Deck Repair

Repair

(Construction Plans, Sheet A1.1)

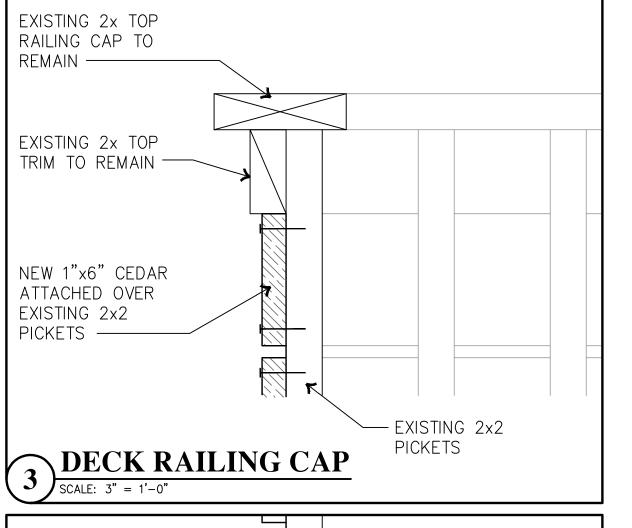
Determine the minimum required specifications for deck beams, posts, post bases, post caps and footings if replacements are necessary. Given the work already completed and the stop-work order in place, establish a clear benchmark to assess the completed work and provide clarity for future construction and inspection, minimizing any potential ambiguities.

(Construction Plans, Sheet A1.1)

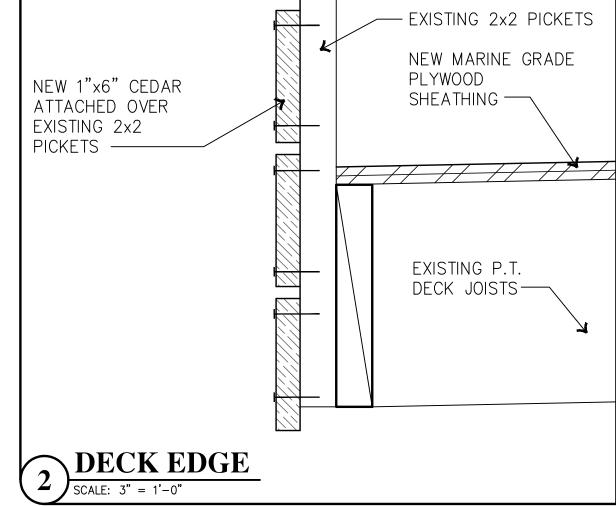
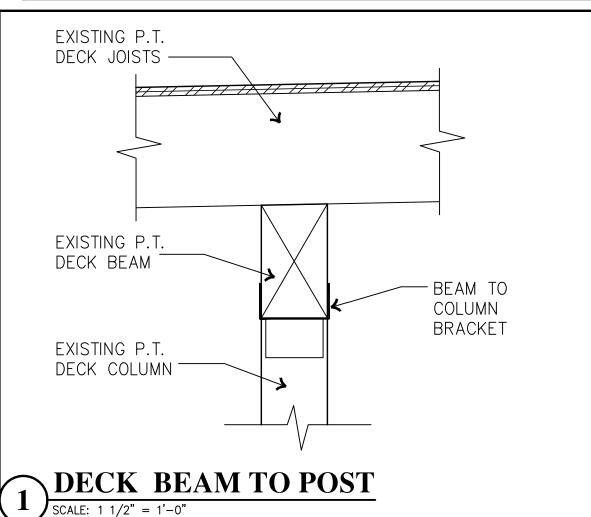
Deck joists appear to be sloped to drain off of the cantilevered side of each deck based upon details 1 and 2. Detail 2 shows the installation of the 1x6 cedar board over the existing 2x2 balusters. detail or notate how the 1x6 cedar will be installed to prevent drainage and water accumulation on the deck surface.

(Construction Plans, Sheet A1.1)

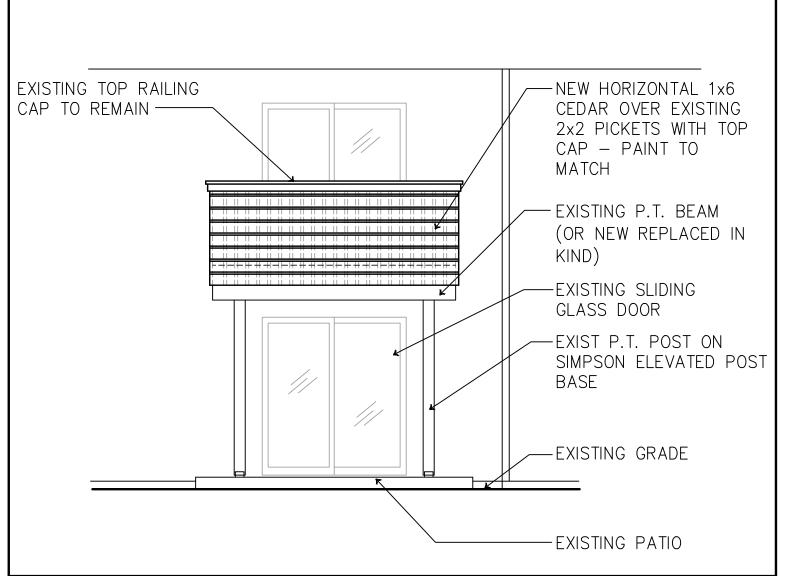
Add a notation on either Sheet A1.0 or A1.1 that contractor shall verify the integrity of balusters prior to the installation of the 1x6 cedar. Establish the parameters of the balusters replacement to include type, grade and nailing pattern.

Typical Deck Plan

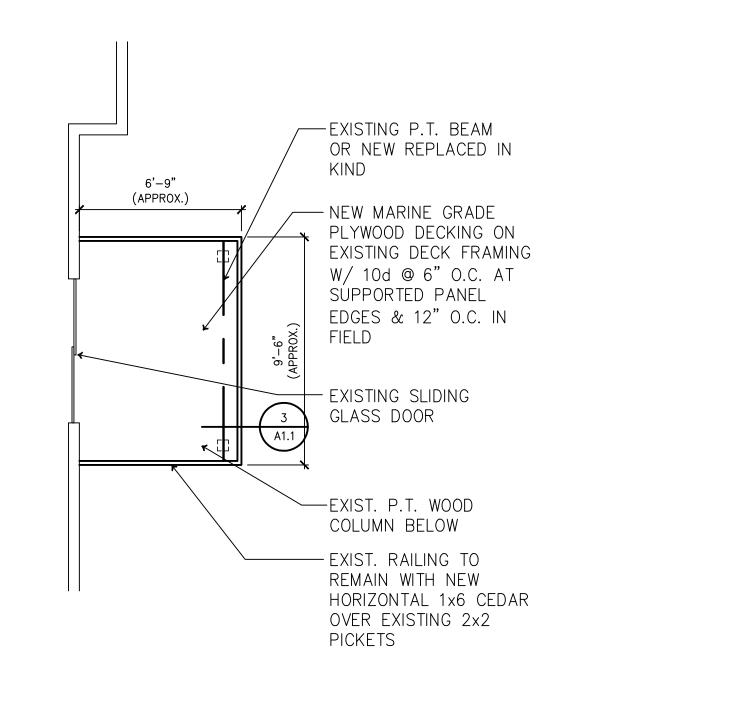
Provide specifics of the plywood that will be installed which should include plywood thickness, grade and any other specifics that will reflect that the plywood will withstand the dead and live loads of the deck. Identify the non-slip surface that will either be provided on the plywood or will be added to the plywood as part of construction, as notated on sheet

The existing joist spacing should also be considered when selecting the plywood material that will be used. Please provide the existing joist spacing.

A1.0, Owner/Contractor Coordination Notes.

Updated all details and notes as needed to reflect the requested information.
